Re: Interpretation for Reston Spectrum L.P., CP 86-C-121-2, Ingress and Egress Adjacent to Building "B"

Re: Reston Spectrum Limited Partnership - Request for Interpretation -
Ingress and Egress Adjacent to Building "B"

The SPECTRUM at Reston Town Center

New Dominion Parkway

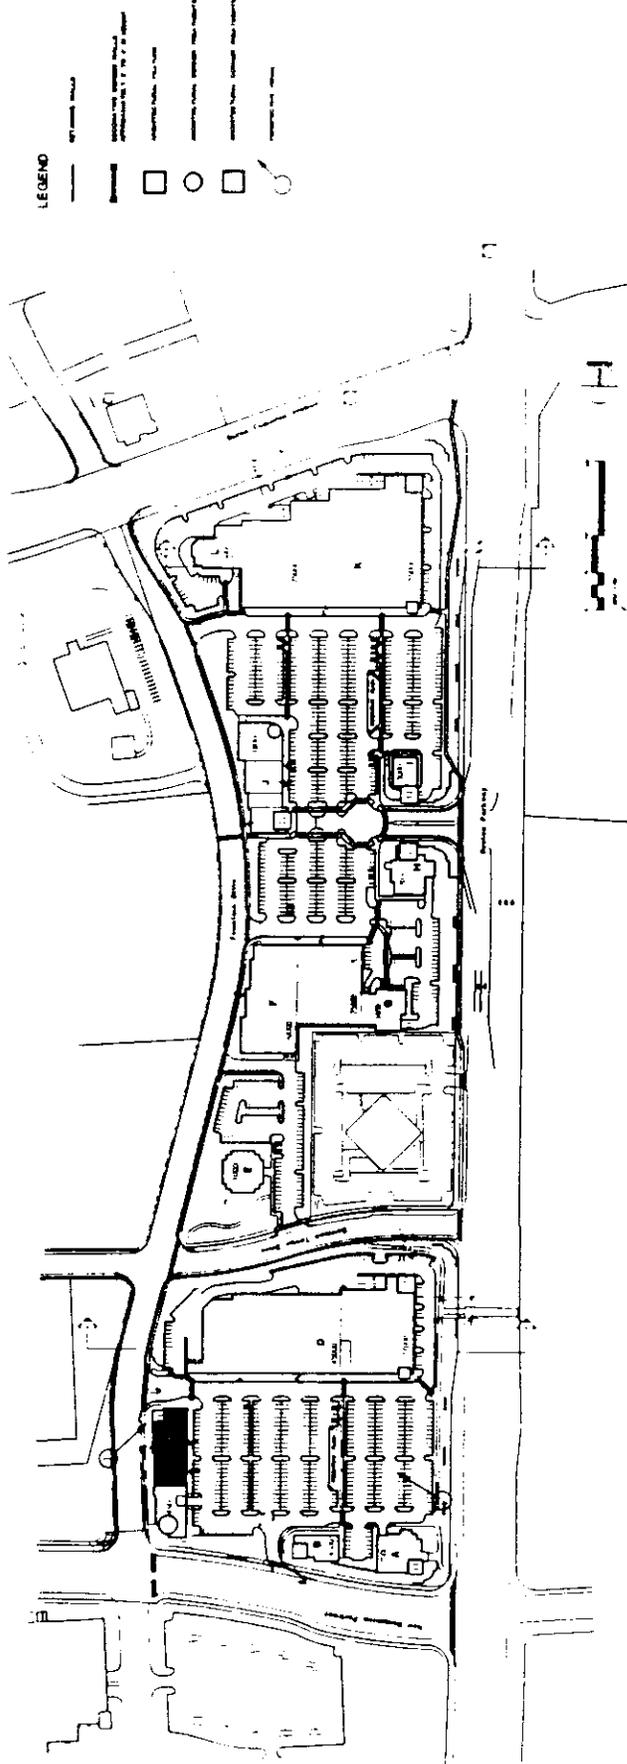
Your revised plan shows a widening of the curb cut, construction of a raised median to separate the ingress and egress points, installing four new stop signs to regulate conflicting traffic movements, providing two painted crosswalks at the intersection of New Dominion Parkway and Fountain Drive, lengthening the median on New Dominion Parkway to ensure that cars utilize the proposed "right out" and do not attempt to cross three lanes of traffic in order to reach the left turn lane into Reston Town Center, and stripping of the intersection.

I have attached for your review a revised Entrance and Roadway Median Plan which shows the approved roadway configuration, as well as the proposed revisions. As shown on this exhibit, Reston Spectrum Limited Partnership is proposing to (1) widen the curb cut; (2) to construct a raised median to separate the ingress and egress points; (3) to install four (4) new stop signs to regulate conflicting traffic movements; (4) to provide two (2) painted crosswalks at the intersection of New Dominion Parkway and Fountain Drive; and (5) to lengthen the median on New Dominion Parkway to ensure that cars utilizing the proposed "right out" do not attempt to cross three lanes of traffic in order to reach the left turn lane into Reston Town Center. The intersection will be appropriately striped.

Since the opening of the Center, several accidents have occurred at this location. Reston Spectrum Limited Partnership, Reston Land Corporation and their engineers, together with VDOT and the Office of Transportation have reviewed the traffic circulation pattern at the Center. All parties are in agreement that widening the curb cut and allowing it to function as a point of ingress and egress is an appropriate measure to improve the safety of the intersection.

It is my determination that the revised layout to permit full turning movements on New Dominion Parkway is in substantial conformance with the approved Conceptual Plan. This determination has been reviewed with the Office of Transportation and has been made in my capacity as the duly authorized agent of the Zoning Administrator.
